Product Group: Vishay Passives / CC and NLR / **September 28th, 2026** / **PCN-NLR-013-2026 Rev 0**

Change to completely Pb-free NTC SMD

PCN-NLR-013-2026 : Change to Pb-free NTC SMD

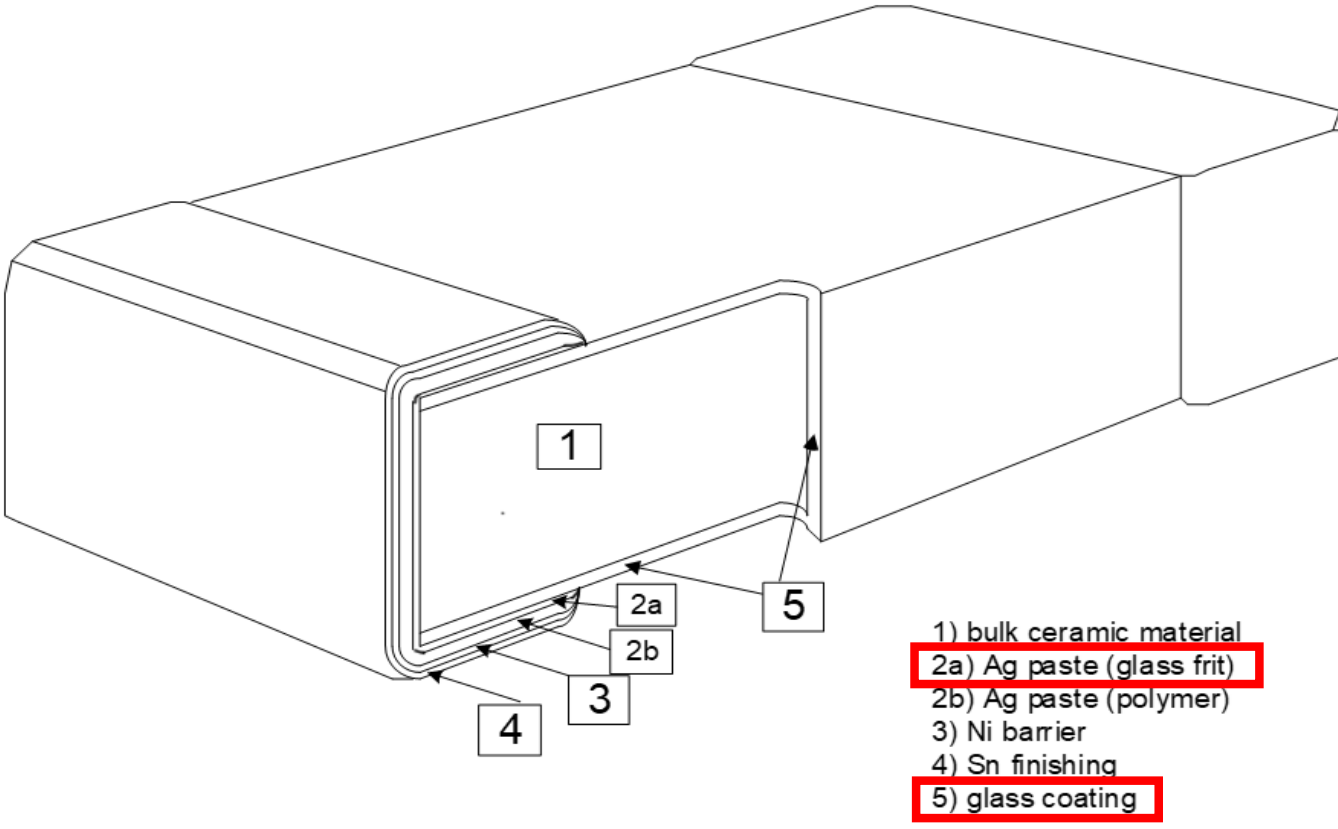
Pb-bearing NTC SMD

Part	Substance	Cas number	weight %
Glass cover (5)	Lead(2+)-silicate	10099-76-0	64%
	Glass without declarable substances	-	36%
Glass Ag Termination (2a)	Silver	7440-22-4	92%
	Lead(2+)-silicate	10099-76-0	5.8%
	Glass without declarable substances	-	2.2%

ROHS Compliant with exemption 7c-I
REACH compliant

Pb-free NTC SMD

Part	Substance
Glass cover (5)	Glass without declarable substances
Glass Ag Termination (2a)	Silver
	Glass without declarable substances

Full ROHS Compliant (no exemptions)
REACH compliant
